DB23-0005 Charbonneau Country Club Tennis Building

**DEVELOPMENT REVIEW BOARD
RESOLUTION NO. 420**

Exhibit A1
Staff Report
Wilsonville Planning Division
Charbonneau Tennis Court Building
Development Review Board Panel 'B'
Quasi-Judicial Public Hearing

Hearing Date:	September 25, 2023
Date of Report:	September 18, 2023
Application Nos.:	DB23-0005 Charbonneau Tennis Court Building - Stage 2 Final Plan Modification (STG223-0004) - Site Design Review (SDR23-0004)
Request/Summary:	The requests before the Development Review Board include a Stage 2 Final Plan Modification and Site Design Review for the addition of a 14,440-square-foot steel frame building over the existing outdoor tennis courts at 32000 SW Charbonneau Dr.
Location:	32000 SW Charbonneau Dr. The property is specifically known as Tax Lot 80000, Section 24DC, Township 3 South, Range 1 West, Willamette Meridian, Clackamas County, Oregon.
Owner/Applicant:	Charbonneau Country Club (Contact: Jim Meierotto and Gary Newbore)
Comprehensive Plan Designation:	Commercial
Zone Map Classification:	Planned Development Commercial (PDC)
Staff Reviewers:	Sarah Pearlman, Assistant Planner Amy Pepper, Development Engineering Manager

DRAWING
C2.0

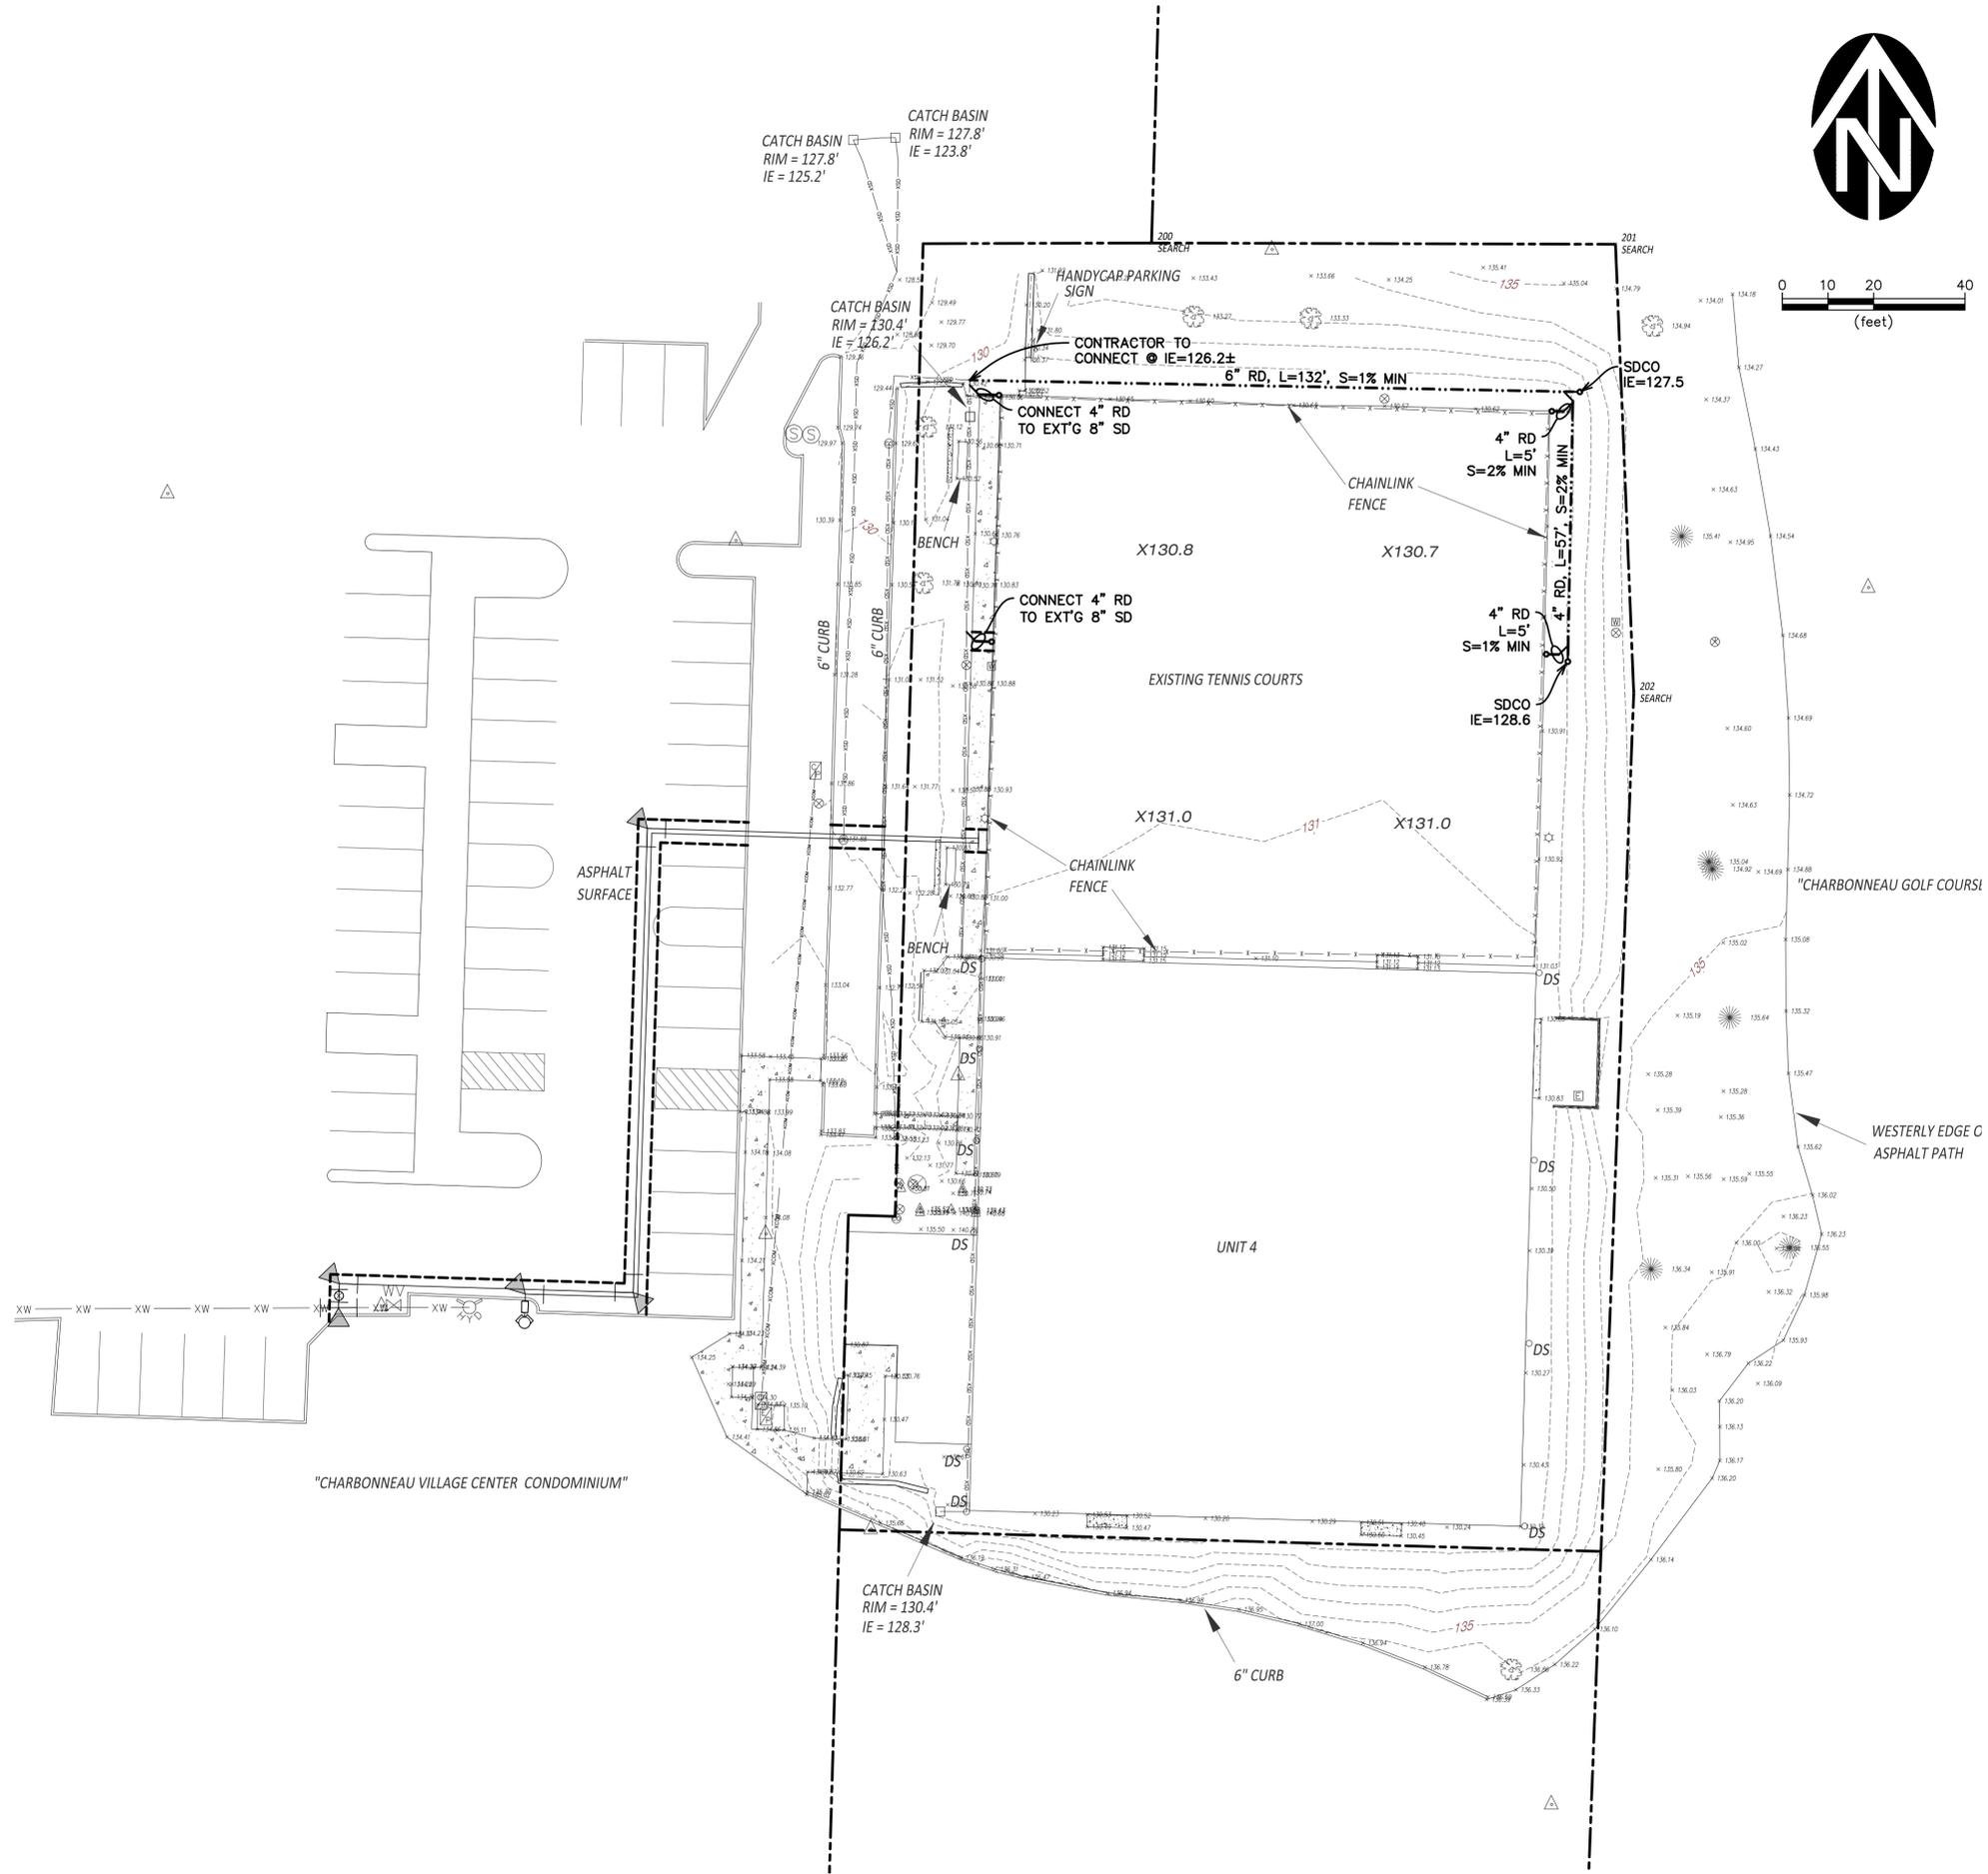
<p>PF 4.</p>	<p><u>Prior to the Issuance of the Public Works Permit:</u> A site plan shall be submitted showing the proposed connection to the public water main for the new fire service connection.</p>
